**LEBANON PLANNING BOARD
JANUARY 8, 2024 - 6:30 PM
COUNCIL CHAMBERS, CITY HALL OR
REMOTE VIA VIRTUAL PLATFORM
LEBANONNH.GOV/LIVE**

Staff Memorandum – PB2024-01-GOV

City of Lebanon (applicant), Mary Hitchcock Memorial Hospital (property owner), 1 Medical Center Drive (Tax Map 10, Lot 8), zoned MC: Request for Site Plan Review to install a water system interconnection and a water booster pump station. PB2024-01-GOV

SITE PLAN
FOR
LOT 78-41
IN
LEBANON, NEW HAMPSHIRE

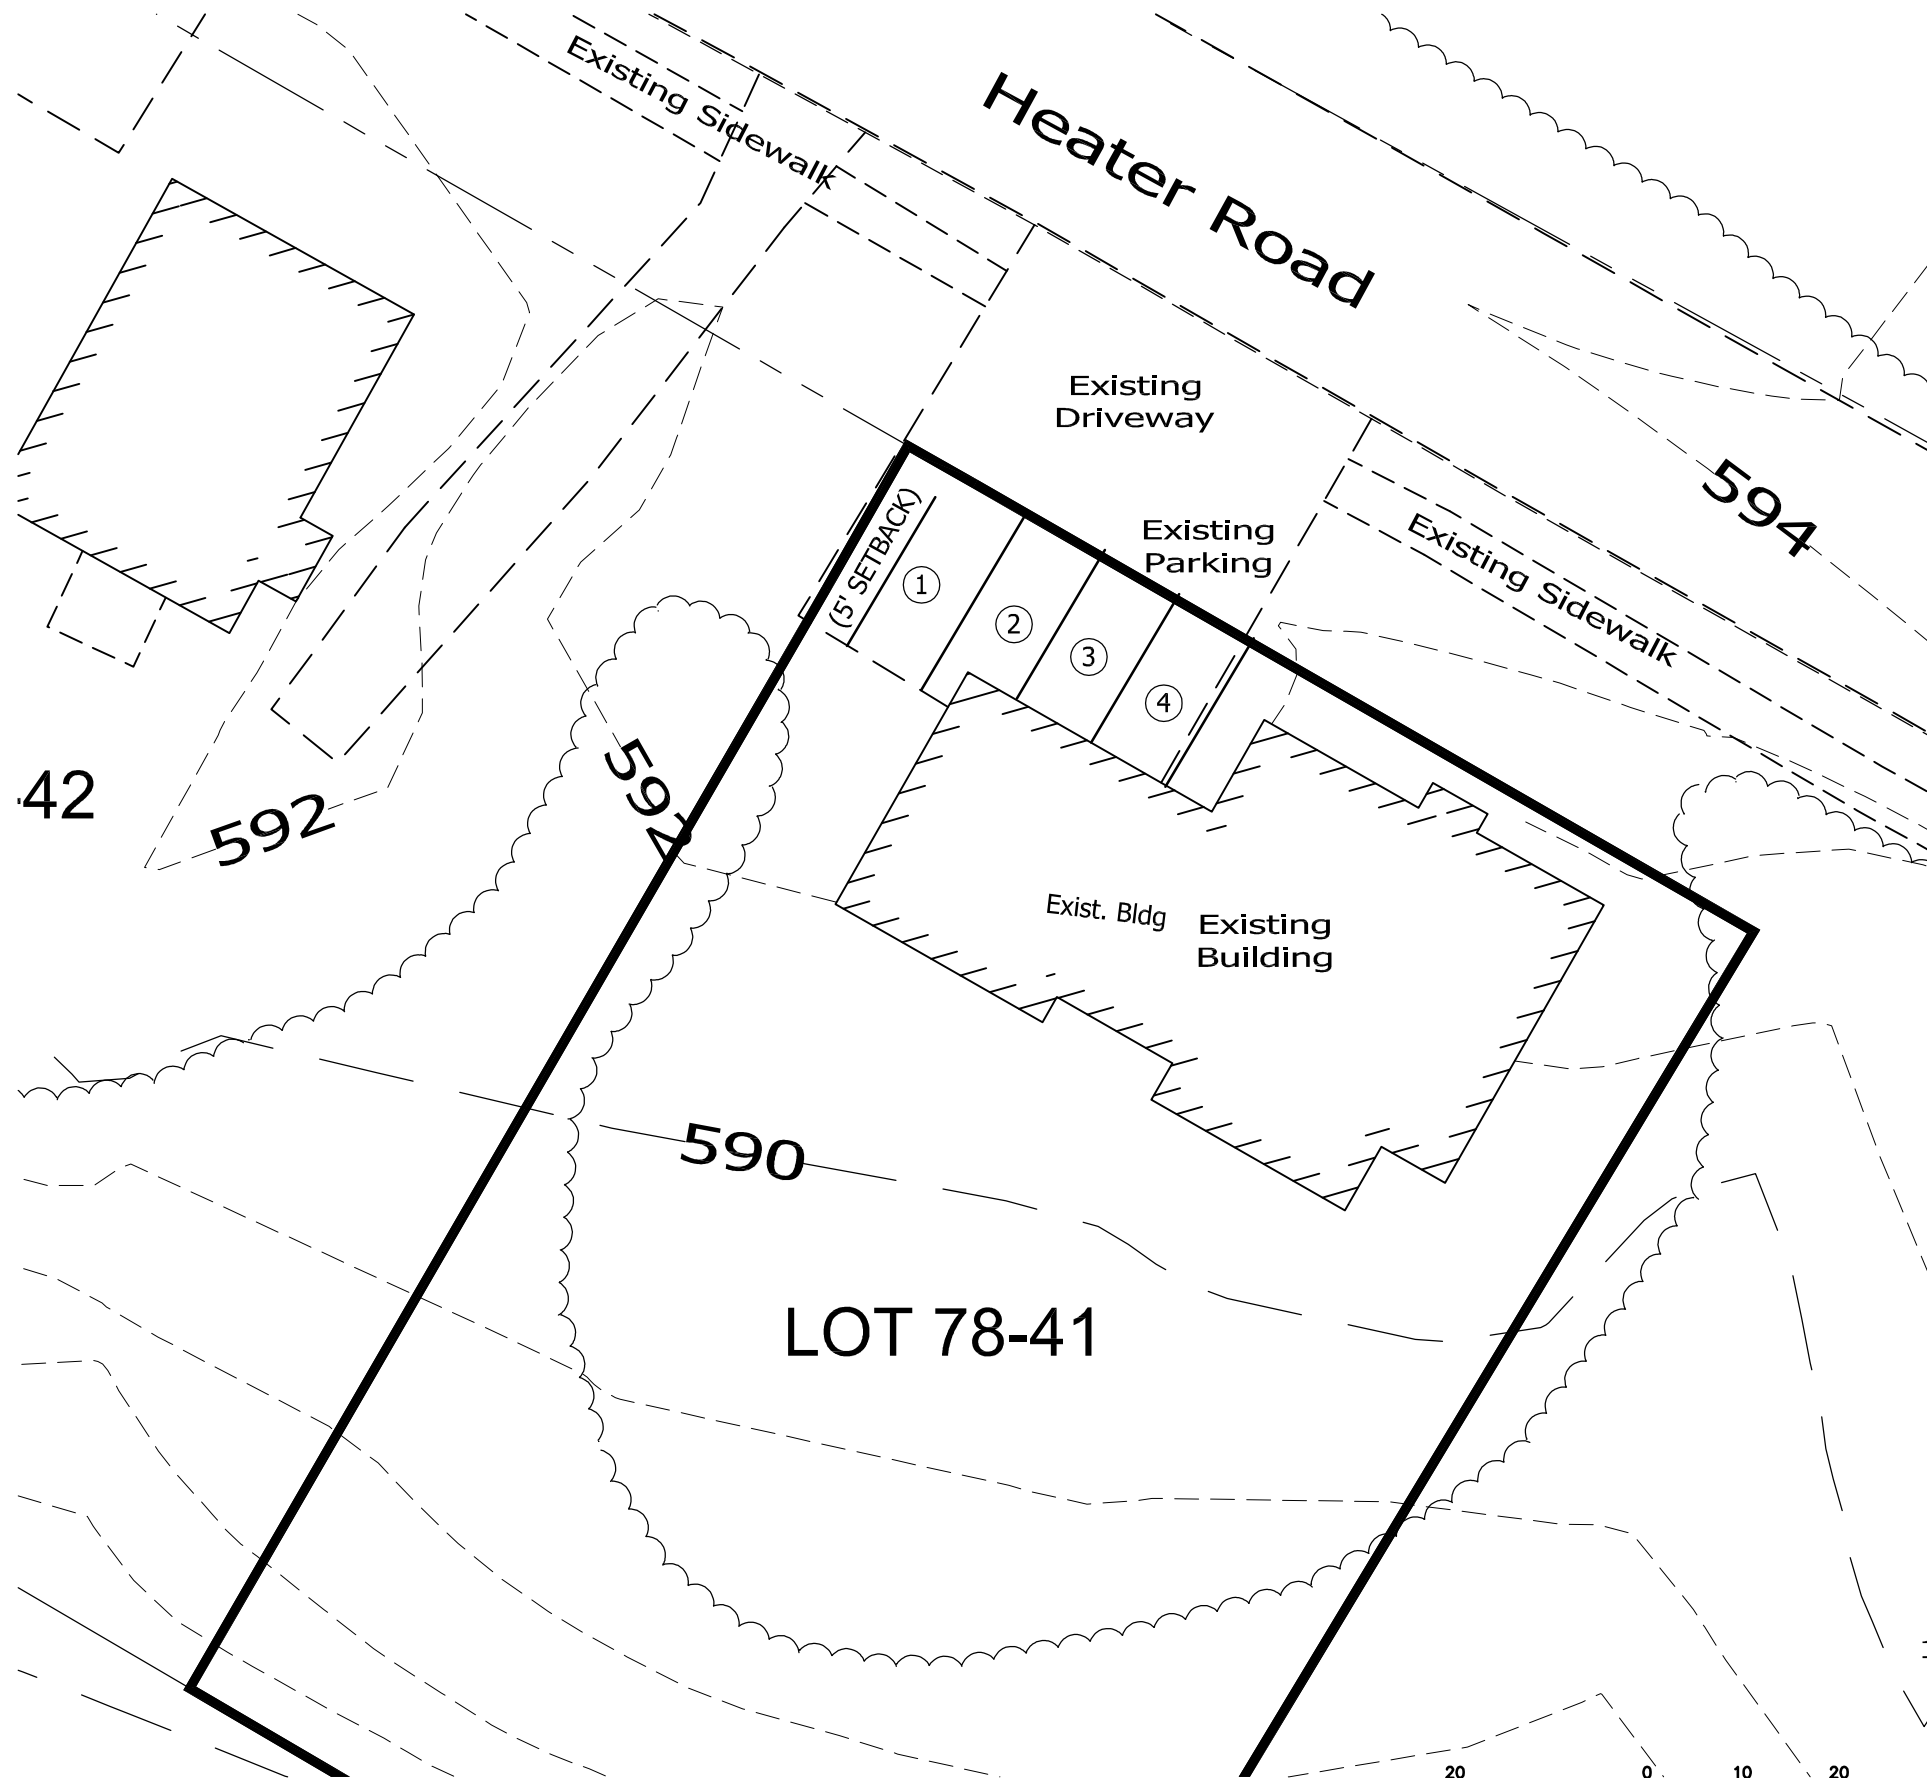
- As noted above, the applicant should clarify the size of the existing dwelling units. Staff also recommends that the applicant provide a floor plan of the apartment to remain in order to verify that it is not proposed to be altered (which may require additional zoning review) and to confirm that it is a one-bedroom apartment (needed to verify the minimum required parking for the proposed mixed use building).

- "No outdoor storage is permitted."
 - "No parking or equipment storage shall be permitted within the City's right-of-way depicted on the plot plan titled, "Site Plan for Lot 78-41," dated 12/21/23, prepared by Advanced Geomatics & Design."

- If the Board moves to approve the application, staff recommends that the Board include the following conditions:
 - "A floor plan shall be submitted identifying the 450 sq. ft. office space within the building and the 1,200 sq. ft. one-bedroom dwelling."
